ADDENDUM NO. 1

Date: August 11, 2023
Project Name: Runway 18L-36R Pavement Reconstruction
Owner: Denton Enterprise Airport
TxDOT CSJ No.: 2318DENTN
Garver Project No. 23A11280

DRAWING NUMBER
CV-106

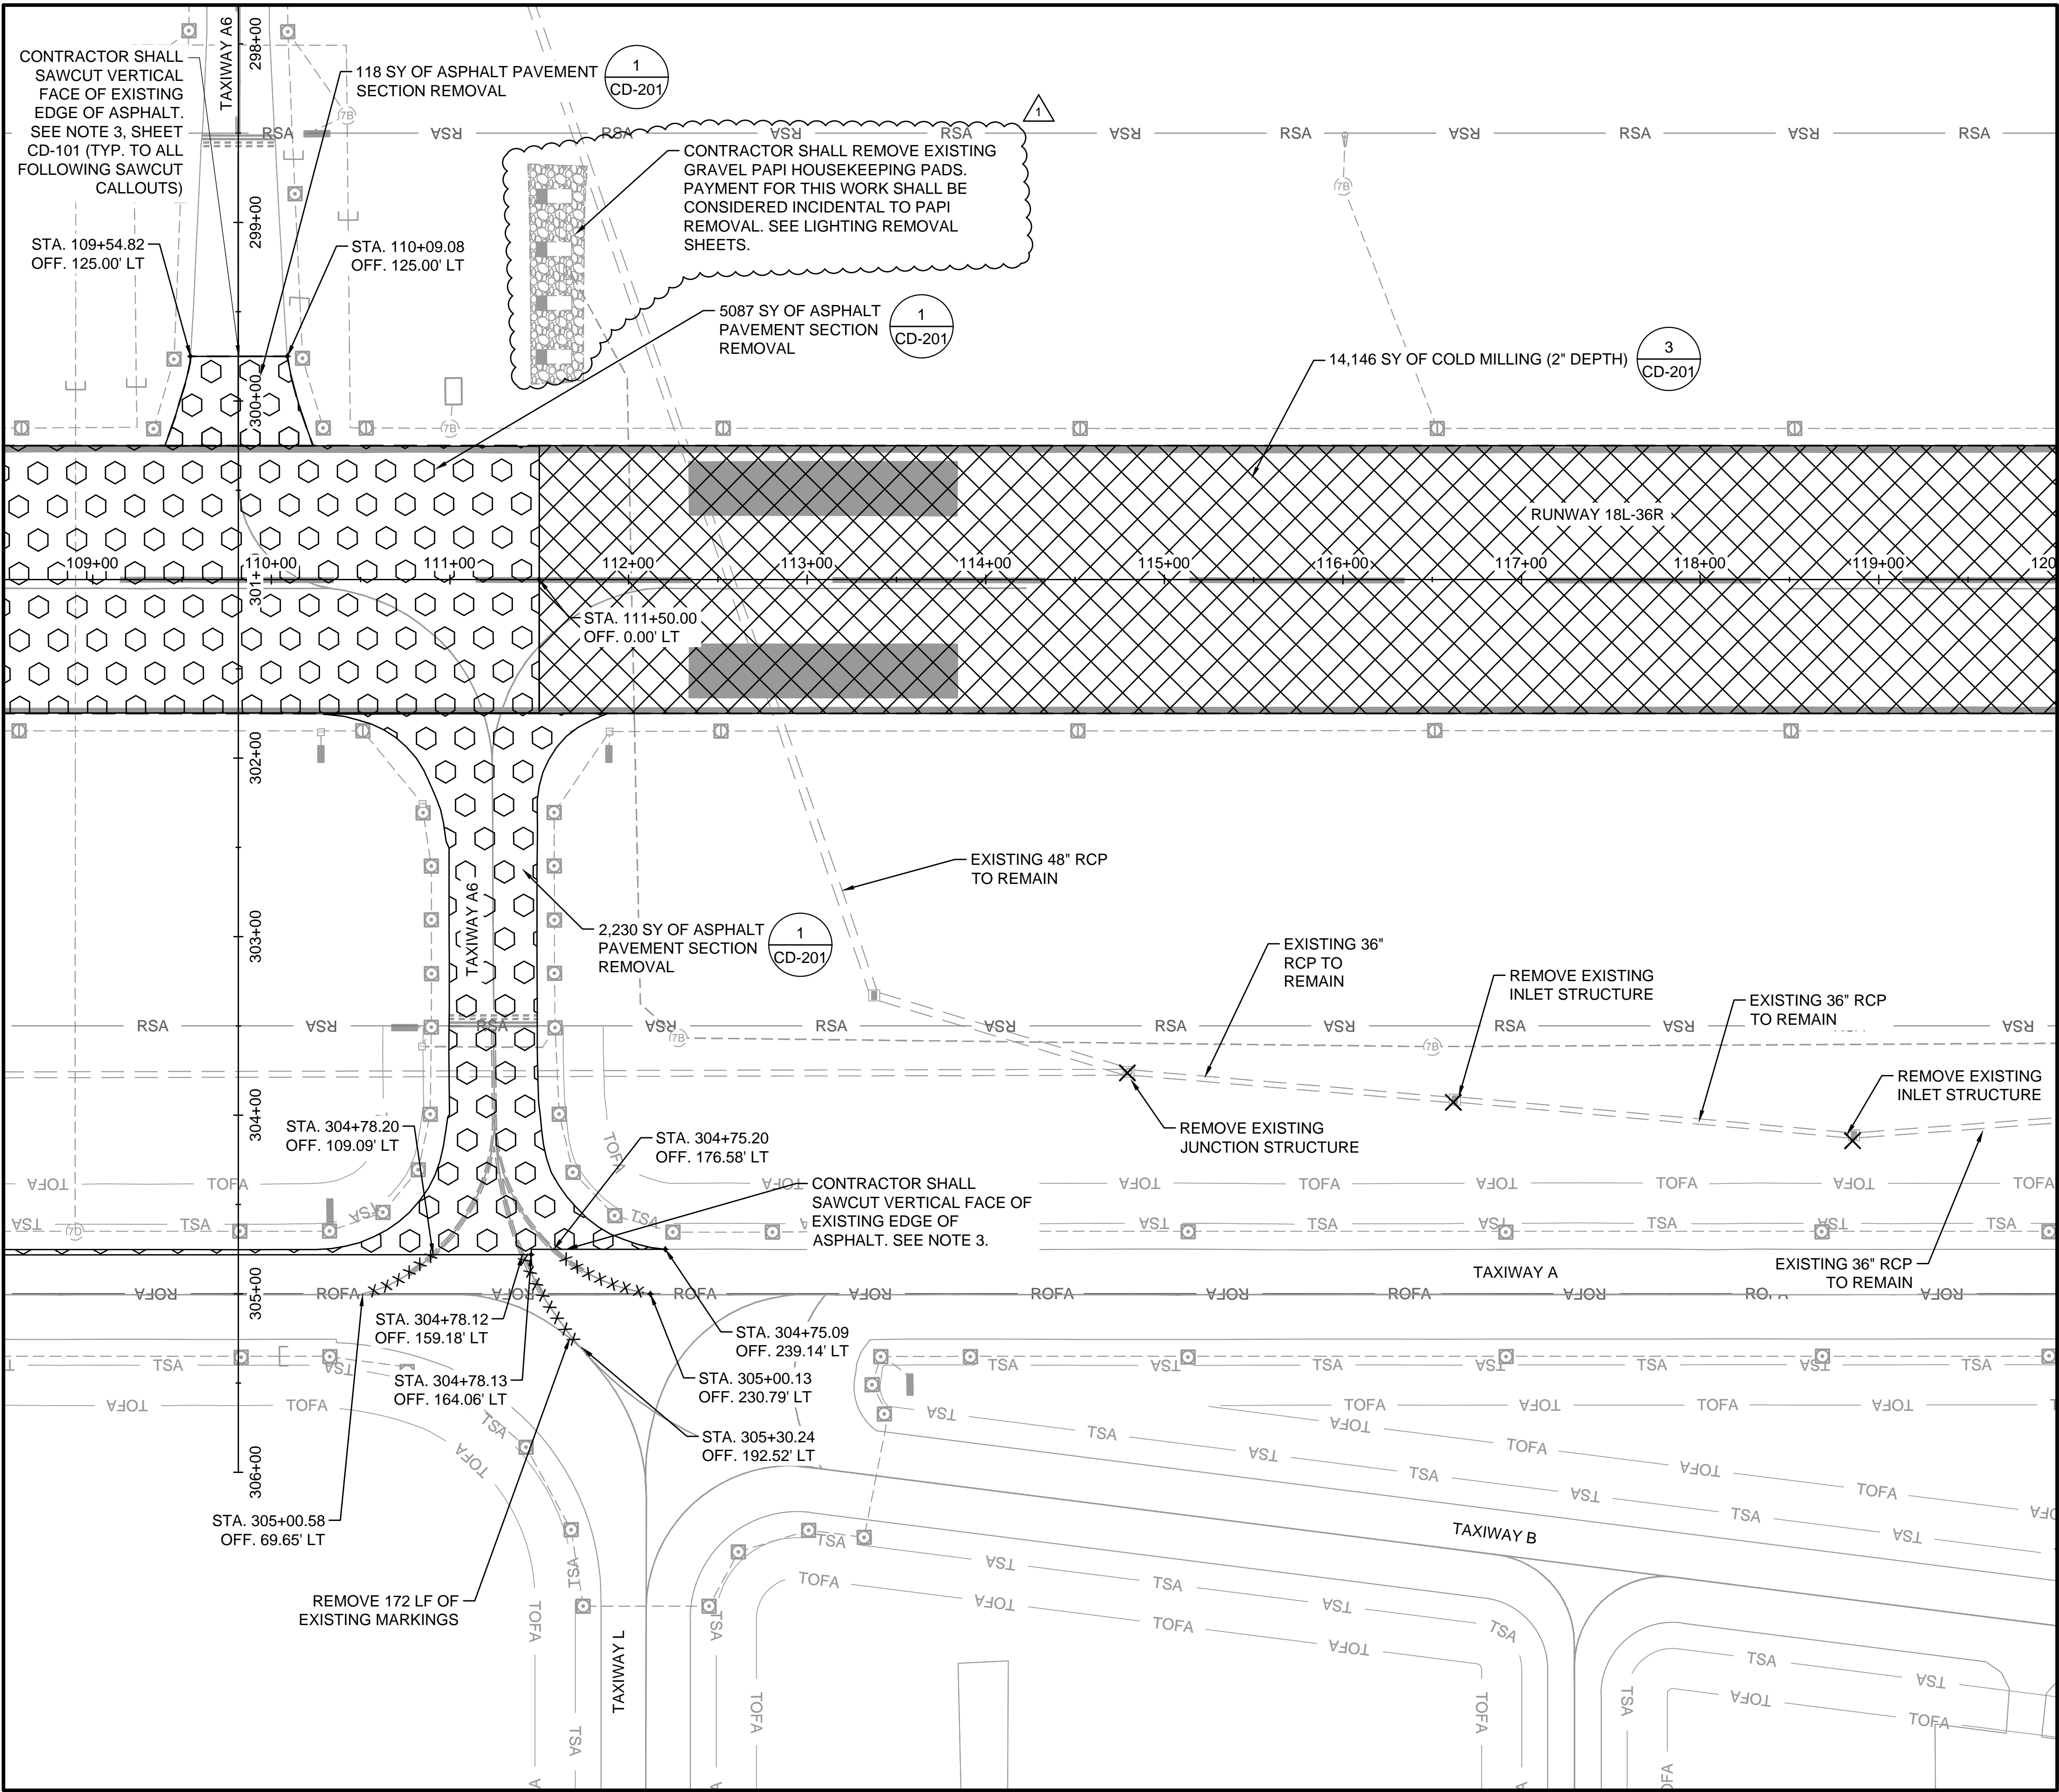
1. Updated Existing Survey Monument Locations, Sheet "CV-101 Existing Conditions"
2. Updated Detail of housekeeping pads to be removed around existing PAPI. Sheet "CV-106 Existing Conditions 6"

DEMOLITION PLAN 2

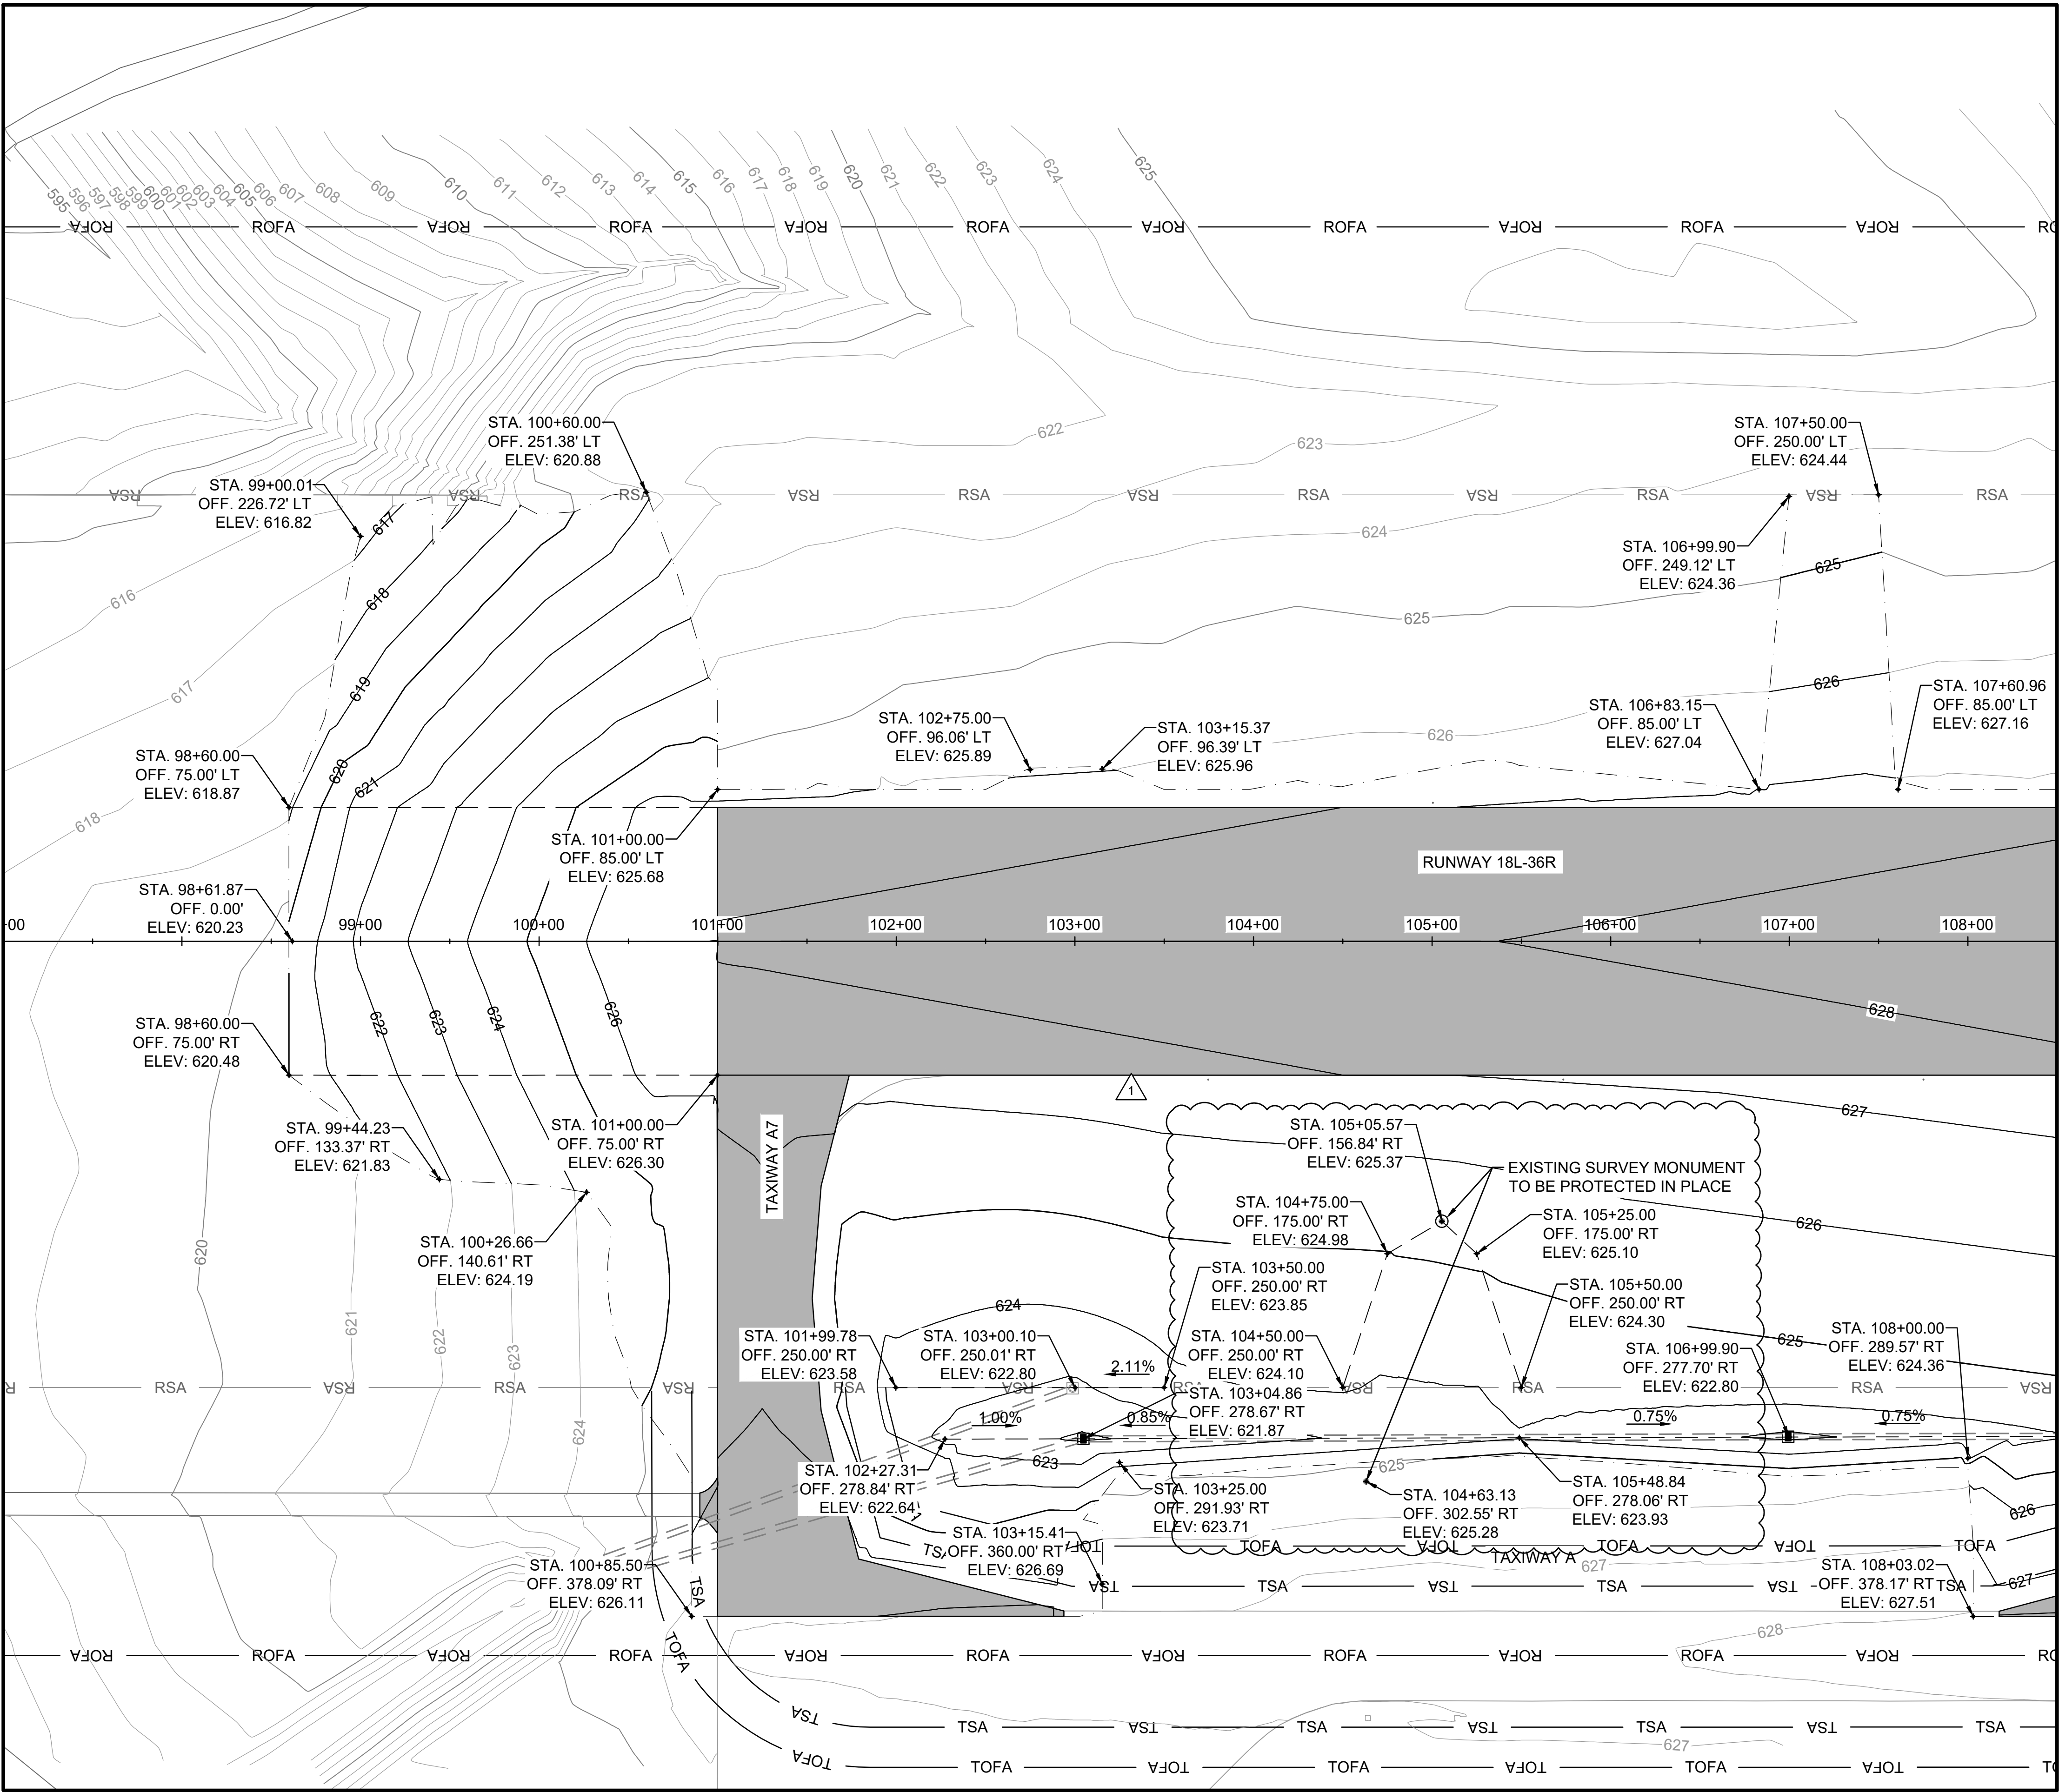
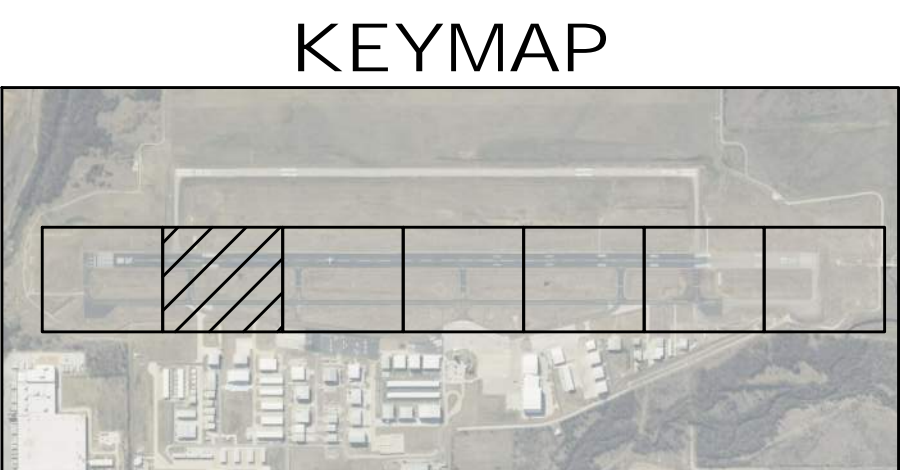
3. Updated Demo Detail of housekeeping pads to be removed around existing PAPI. Sheet "CD-102 Demolition Plan 2"
4. Updated Grading Plans around Existing Survey Monument Locations, Sheet "CG-101 Grading Plan 1"
